ADDENDUM NO. 2

March 1, 2022

**TIMOTHY BALL ELEMENTARY SCHOOL ADDITIONS, RENOVATIONS,
AND RELATED WORK
Crown Point, IN 46307**

This Addendum forms a part of and modifies the Bidding Requirements, Contract Forms, Contract Conditions, the Specifications, and the Drawings dated February 7, 2022 by Gibraltar Design. Acknowledge receipt of the Addendum in the space provided on the Bid Form. Failure to do so may subject the Bidder to disqualification.

DRAWING
UNIT "A" SECOND FLOOR &
UNIT "B" MEZZANINE
ELECTRICAL LIGHTING PLANS

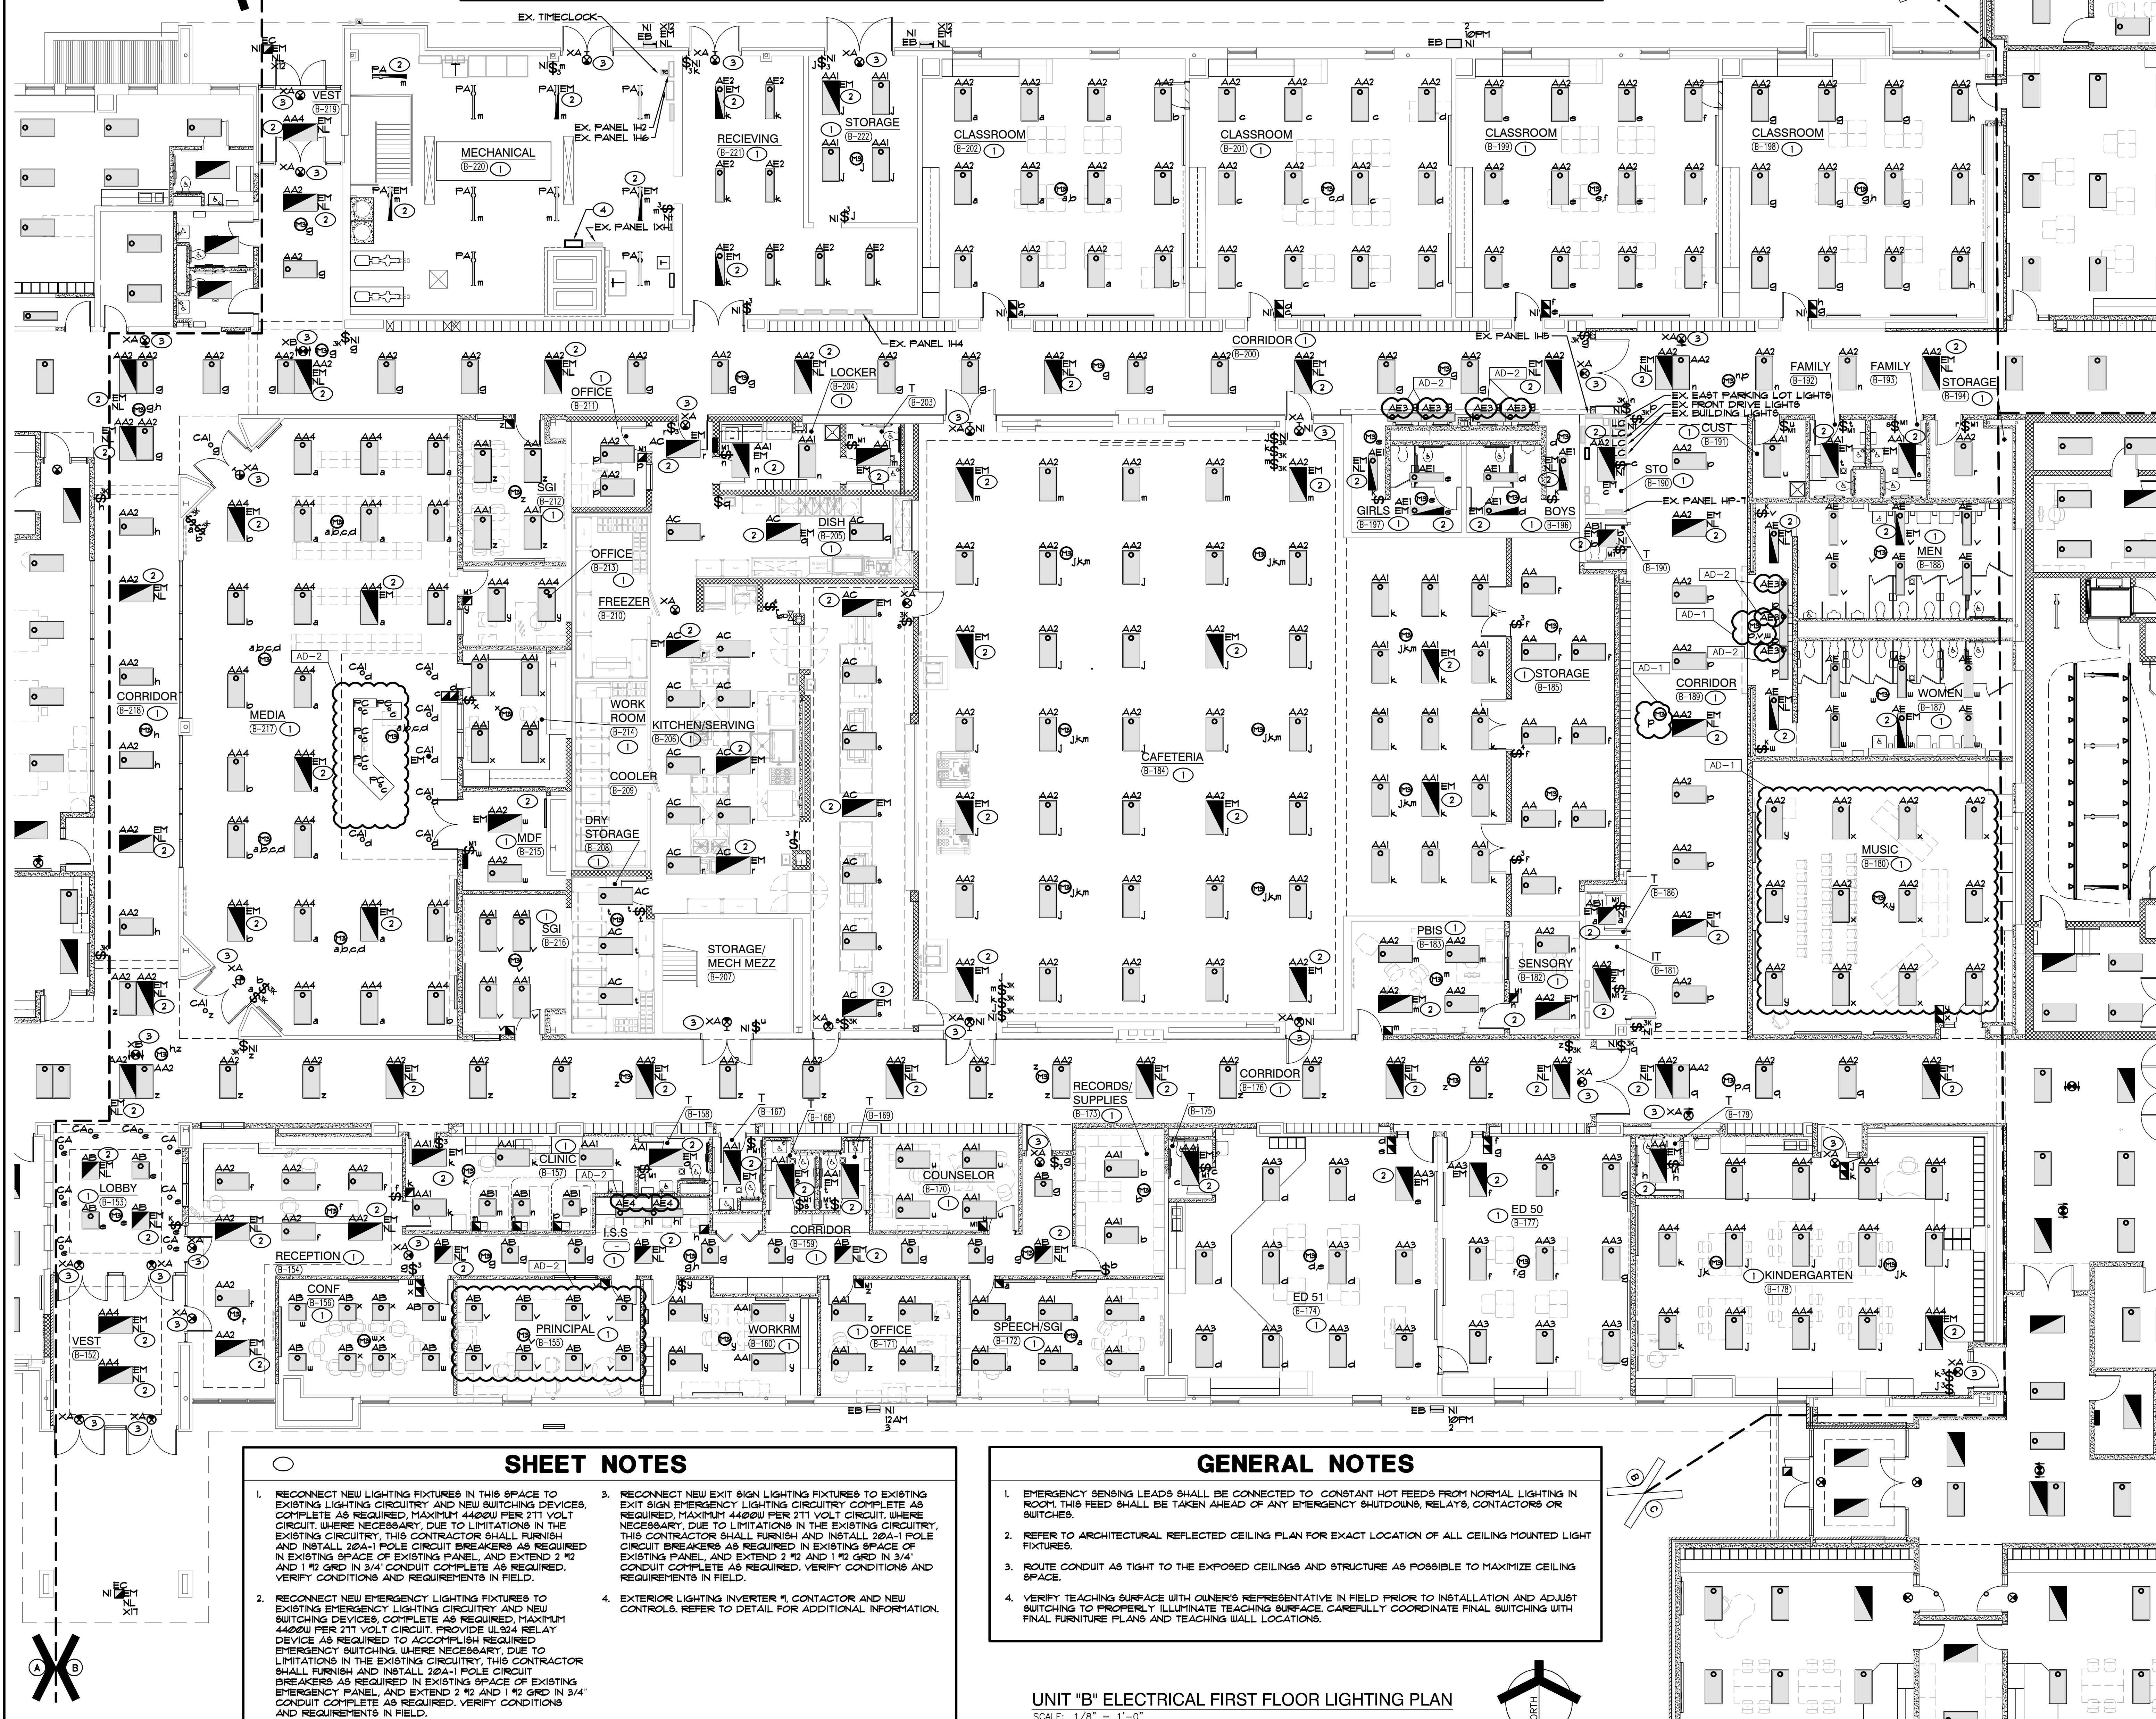
38. Sheet EL102

- A. Refer to revised, full size drawing, included in this Addendum, for the following revisions:
 - 1. Revised lighting fixture types.
 - 2. Revised lighting fixture locations.
 - 3. New location of lighting basement plan.
